**FILE:** IM000-0020-02(117) Richmond **OFFICE:** Engineering Services  
P.I. No.: 210327  
I-20 over Augusta Canal & Savannah River **DATE:** July 29, 2011

**SUBJECT: IMPLEMENTATION OF VALUE ENGINEERING STUDY ALTERNATIVES**

**RE: Value Engineering Study Alternatives for I-20 Over Augusta Canal and I-20 Over Savannah River, P.I. No. IM-20-2(117)**

## PLAN AND PROFILE OF PROPOSED I-20 BRIDGE REPLACEMENT AT SAVANNAH RIVER

RECOMMENDATION 1.0

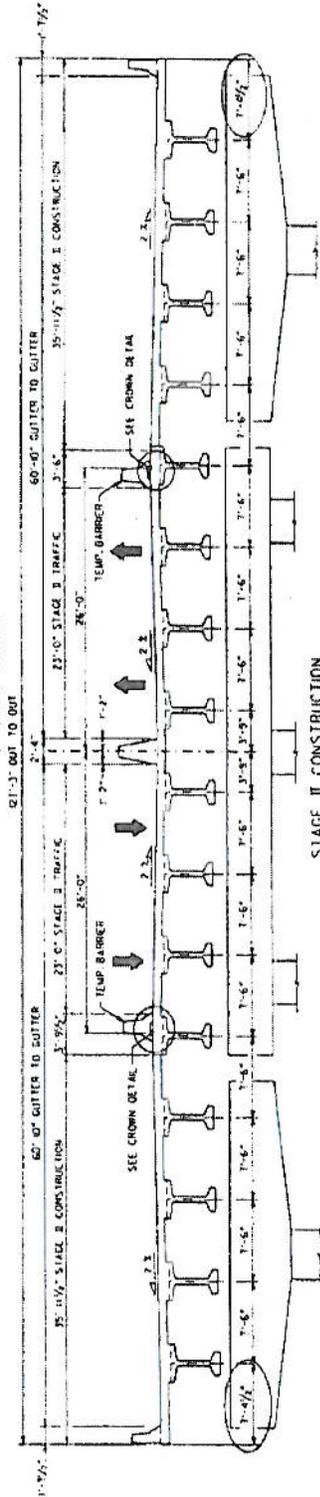
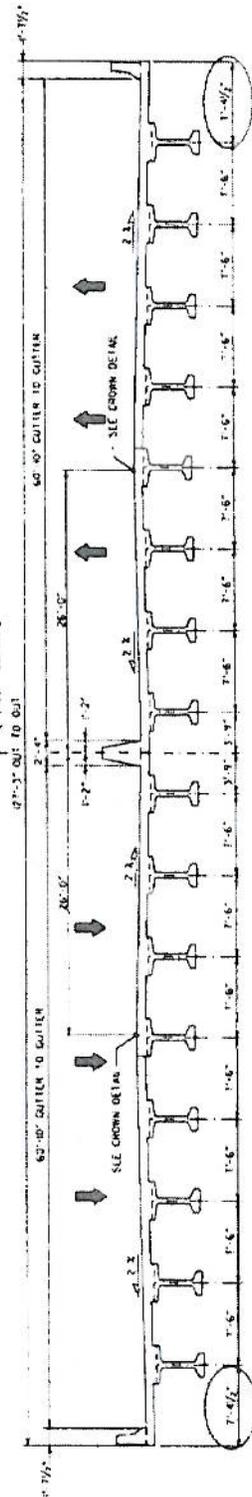
1. Recommendation 1.0: Optimize span lengths on Augusta Canal Bridge using BT-54 girders (112'-6" spans).

VE Team Savings: \$85,228.

No, will not implement. This recommendation shall not be implemented at this time but will be considered at a later date. The VE recommendation suggests reducing the beam spacing, allowing more beams to handle the load for longer lengths, and reducing the number of substructure units. The recommended beam spacing would cause the existing structures to be impacted and require bolting the temporary barrier over the beam probably damaging it. It also would require an additional beam line to handle the larger overhang and meet the needs of the roadway in the final condition (see attached Recommendation 1.0 Typical Section). An alternate beam spacing may meet the needs of the staging and final condition while making it cost effective to remove one of the substructure units. At this point in the concept stage the actual bridge length has not been determined therefore the actual beam type and span configuration will need to be re-evaluated in the future.
